Avon Advisory Planning Commission Meeting  
**Monday, February 23, 2026** at 6:30 pm  
at Avon Town Hall

Planning & Building Department Staff Report

<b>A. PETITION NUMBER</b>	DPR 25-12: 267 Park Place Crossing
<b>B. APPLICANT</b>	Tranquility, LLC, by Kruse Consulting, Inc.
<b>C. LOCATION</b>	56, 82, & 108 Park Place Boulevard (approximate addresses)  Lots 5, 6, & 7 in Avon Park Place
<b>D. PARCEL SIZE</b>	1.68 acres
<b>E. LAND USE &amp; ZONING</b>	The site is undeveloped, is zoned C-2: General Commercial District, and located within Tiers 1 & 2 of the U.S. Highway 36 Zoning Overlay.
<b>F. ACTION REQUESTED</b>	Request for approval of a Development Plan Review to allow for construction of a one-story, multi-tenant commercial building with surface parking and related improvements.
<b>G. HISTORY</b>	<p>The site was platted and recorded in 1988 under the jurisdiction of Hendricks County.</p> <p>This petition was discussed at the September 18, 2025 Technical Advisory Committee (TAC) meeting, and accordingly docketed for the October 27, 2025 Plan Commission (PC) meeting. The petition was continued to the December 22, 2025 meeting, and then to the January 26, 2026 hearing to allow for th

## Exhibit B2 – Revised Site Plan (6-Feb-2026)

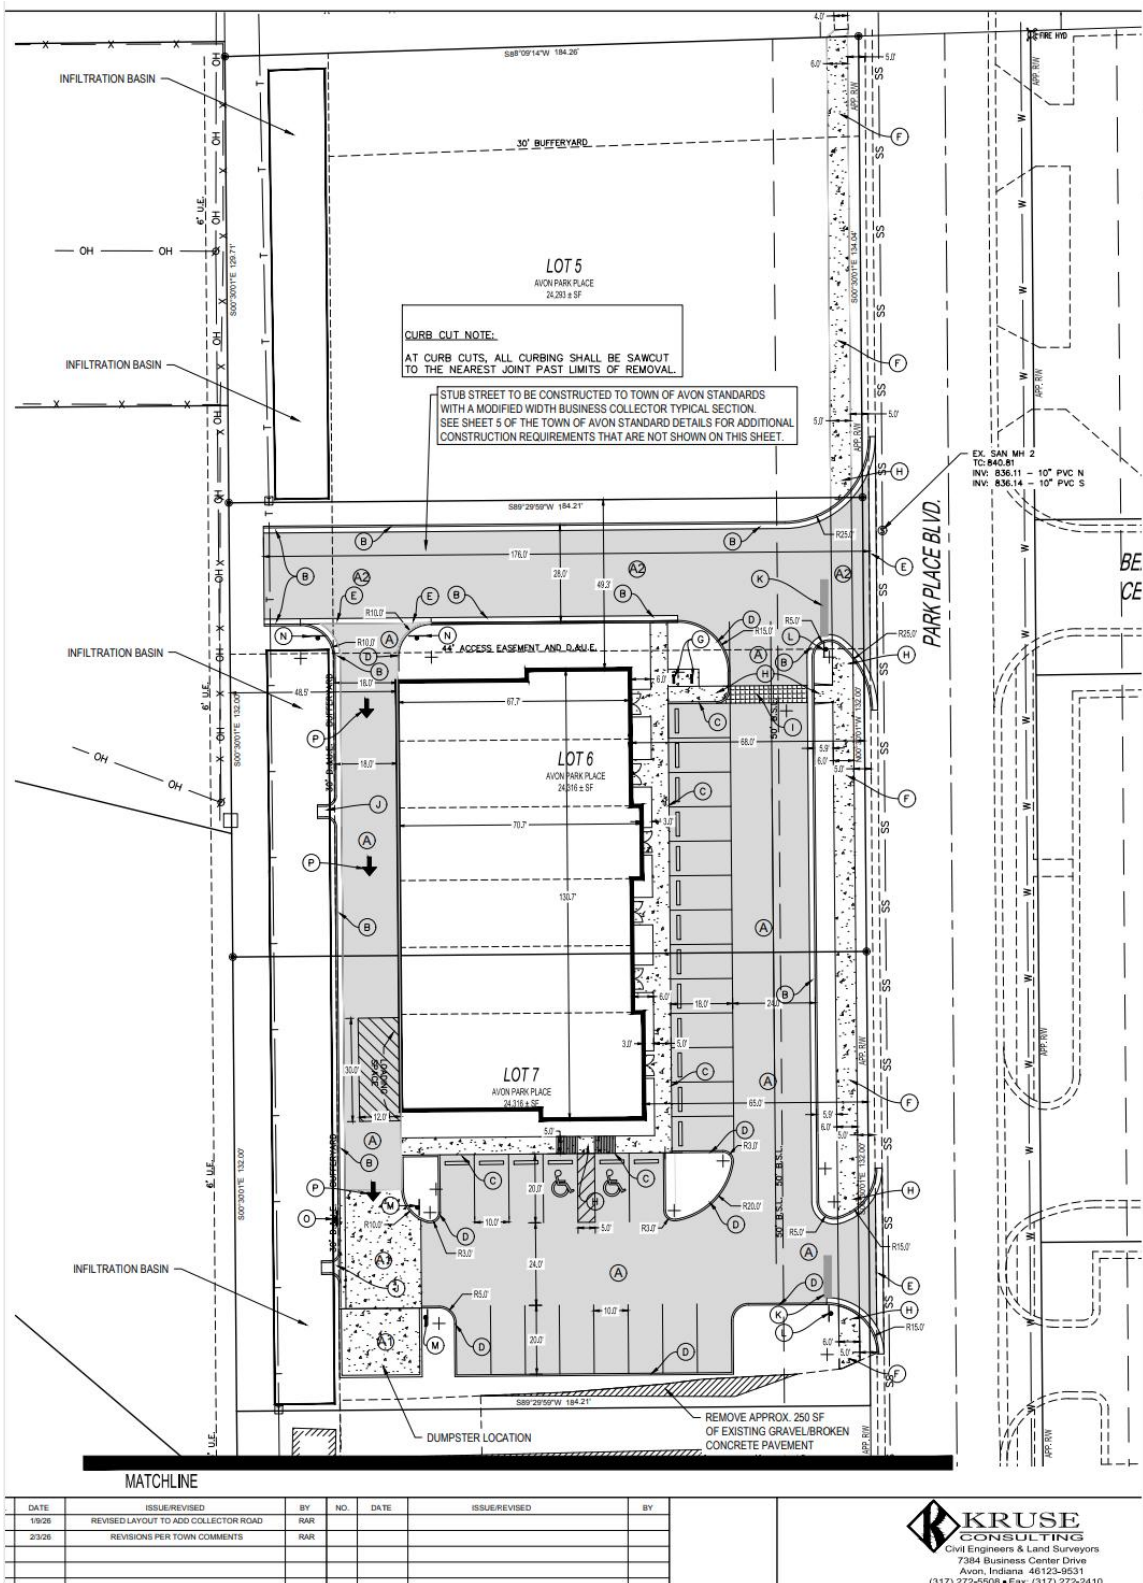
2. Per comments from the Department of Public Works and UDO 2.10(L), an extension of the business collector street (Beechwood Centre Road) identified in the Town of Avon Thoroughfare Plan must be constructed with development of this site. The site plan will need to be revised to relocate the proposed improvements to accommodate said street extension.

7. Per UDO 2.10(M)(1), a minimum 20' deep front yard landscape buffer is required. The submitted plans are deficient. Please revise plans accordingly or request a variance or waiver (if eligible).

12. Per UDO Table 6.1, 90-degree angle parking requires 20-foot deep spaces, however, 18-foot deep spaces are shown in one of the rows. A variance or waiver can be requested, or the plans will need to be revised accordingly.

18. Per UDO 6.11(D)(3), the first twenty (20) feet of a drive must be kept free from parking maneuvers. The parking space at the southeast corner of the site would violate this requirement. Please revise plans accordingly.

# Exhibit B3 – Revised Landscape Plan (6-Feb-2026)

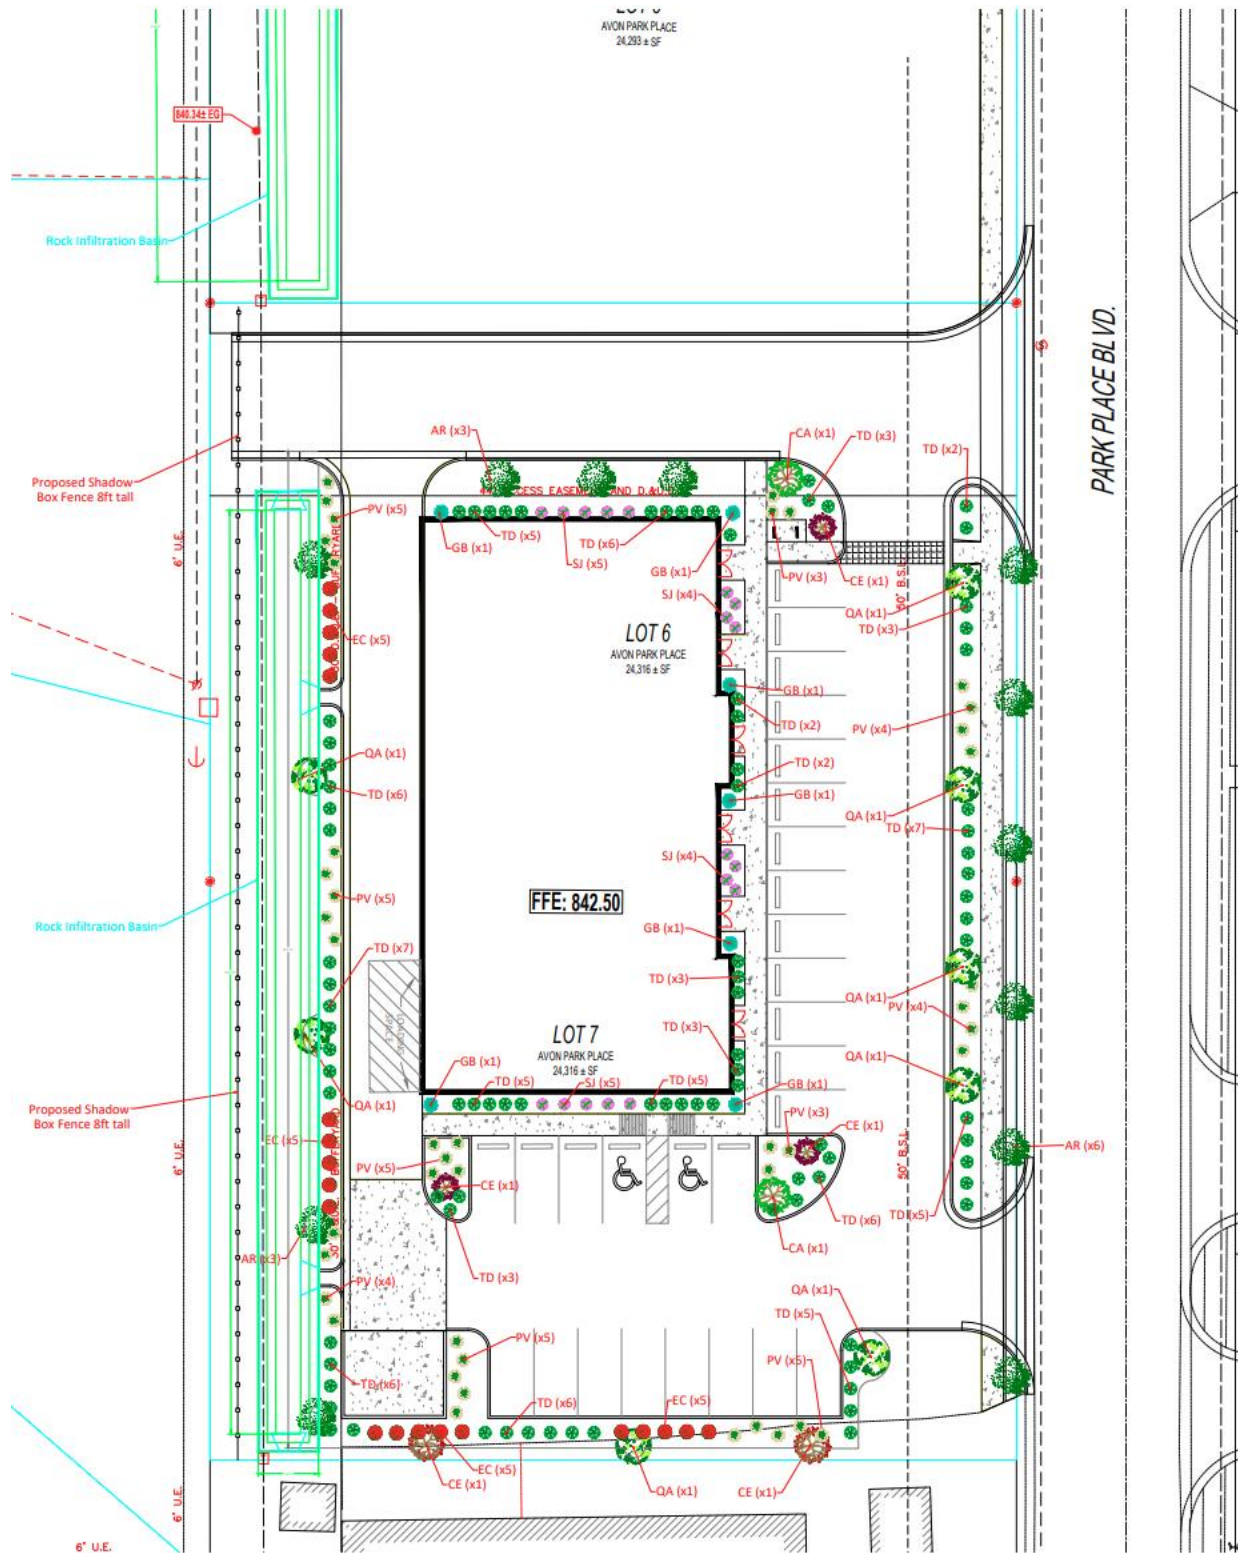
8. Per UDO 6.6(C), one parkway tree is required to be planted in the right-of-way per 50 lineal feet of frontage. No parkway trees are indicated on the submitted landscape plan. Please revise the landscape plan accordingly.

9. Per UDO 2.10(M)(4) & UDO 6.7(C), two (2) shade trees per seventy feet of lineal feet of parking lot perimeter are required. This appears to require four trees along the east perimeter and six along the west perimeter, where only three and four respectively are shown on the landscape plan. Please revise the landscape plan accordingly.

10. Per UDO 6.7(C)(2)(b), a continuous dense hedge running the length of the parking lot is required abutting the west and north perimeters of the lot, and covering 75% of the east and south perimeters of the lot. Please revise the landscape plan accordingly.

11. Per UDO 6.8(D), a solid, year-round screen at least 8 feet high is required within the north and west buffer yards. A 6-foot high shadow box fence is proposed on the landscape plan. Please revise plans to indicate compliance with one or more of the options listed in UDO 6.8(D).

19. Per UDO 6.5(A), a minimum five (5)-foot wide landscaped strip is required around the perimeter of all principal buildings exclusive of doorways and loading areas. The west façade and portions of the east façade do not appear to meet this requirement. Please revise plans accordingly.

# Exhibit B2 – Revised Site Plan (12-February-2026)

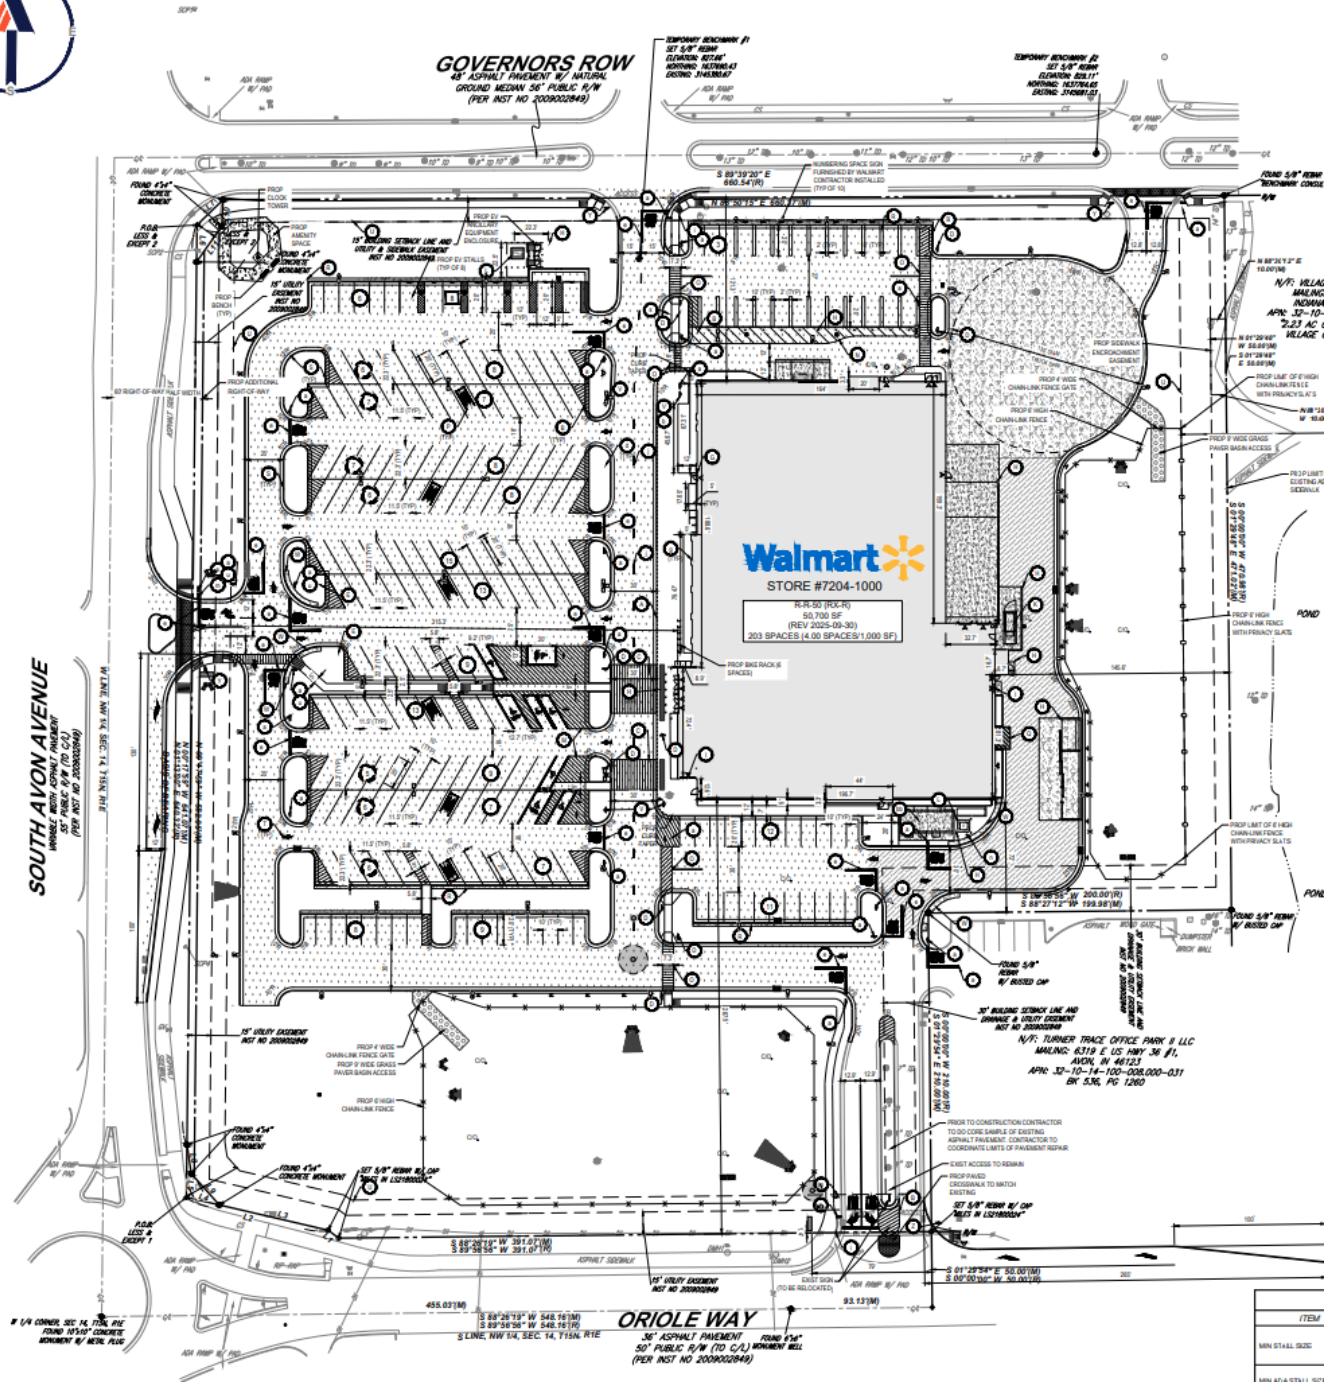
- c) **Bicycle Parking:** The UDO requires one bicycle rack per every twenty (20) required vehicle parking spaces, thus, six (6) bicycle racks would be required. While the revised site plan shows bicycle racks in a compliant location, the plan only indicates five racks. At least one additional rack would be required.

# Exhibit C1 – Revised Landscape Plan (2-January-2026)

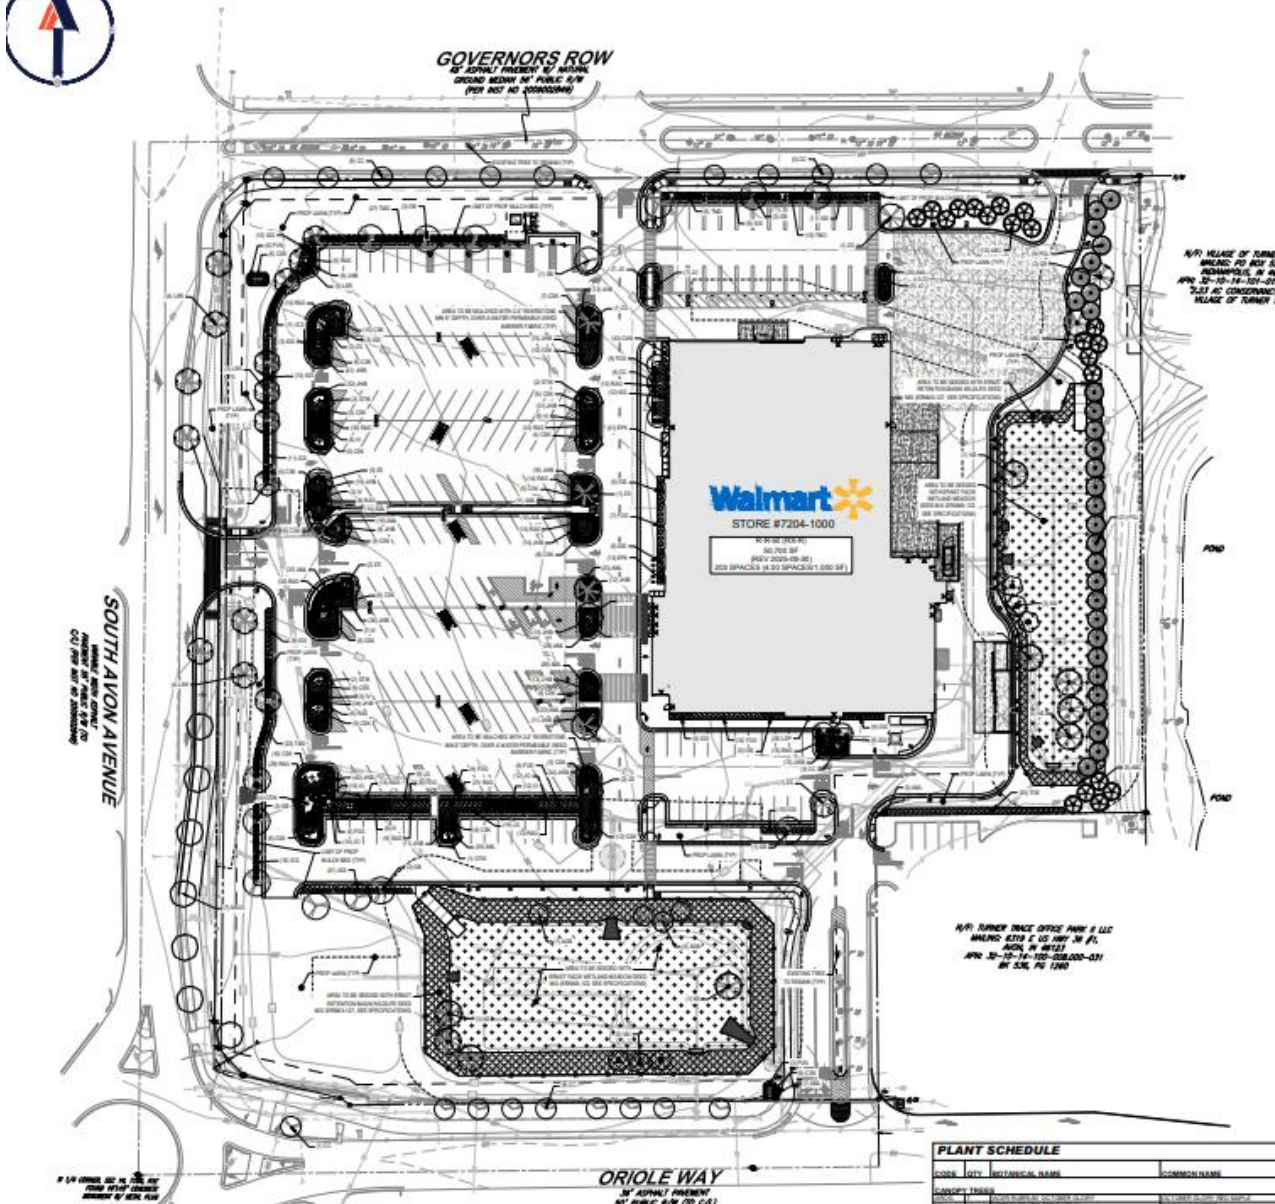
Per UDO 6.5 (A), a minimum five-foot planting area must be provided around the perimeter of the building, excluding access to the buildings, such as loading areas and doorways. The landscape plan submitted subsequent to TAC review has increased the proposed foundation planting areas, but is still deficient along several portions of the building (see Exhibits C1 & C2).

Per UDO 6.7(B)(4), each parking lot landscape island must have a minimum of one tree. The revised landscape plan is still deficient of this standard.

A further revised landscape plan should be submitted to demonstrate compliance with the foundation planting and interior parking lot landscaping requirements.

Presentation Elevations

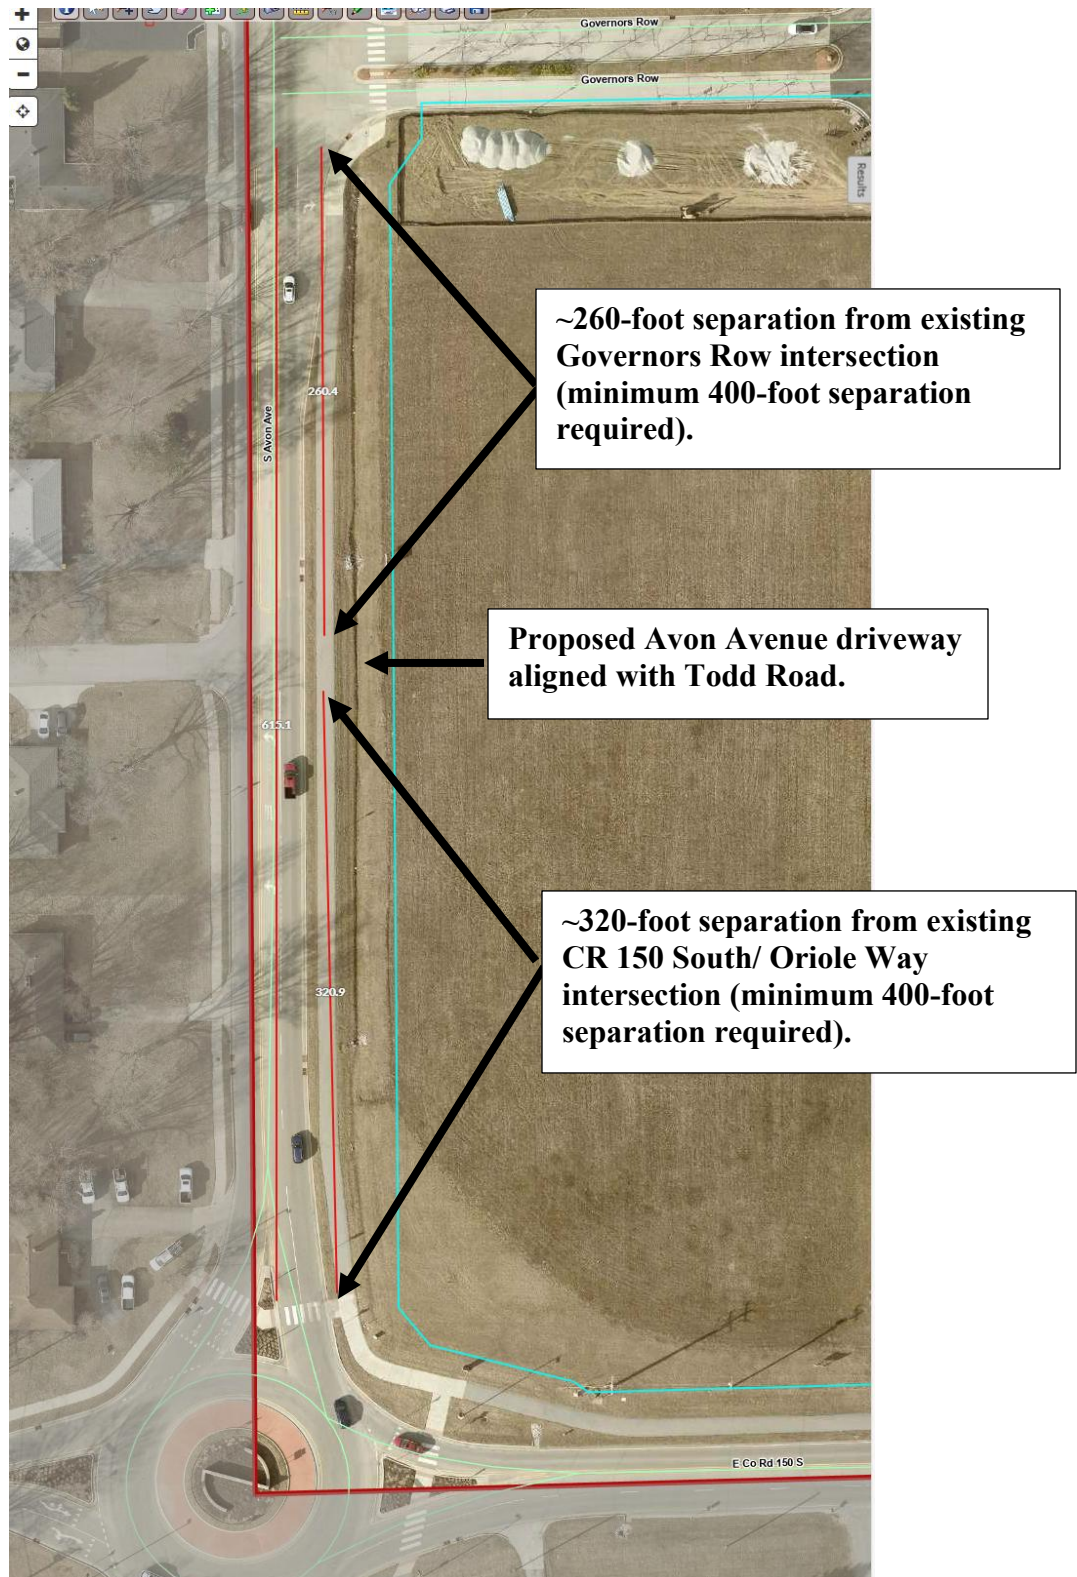
The revised building elevations, submitted subsequent to TAC review, appear to be deficient of several of the architectural standards (see Exhibit D).
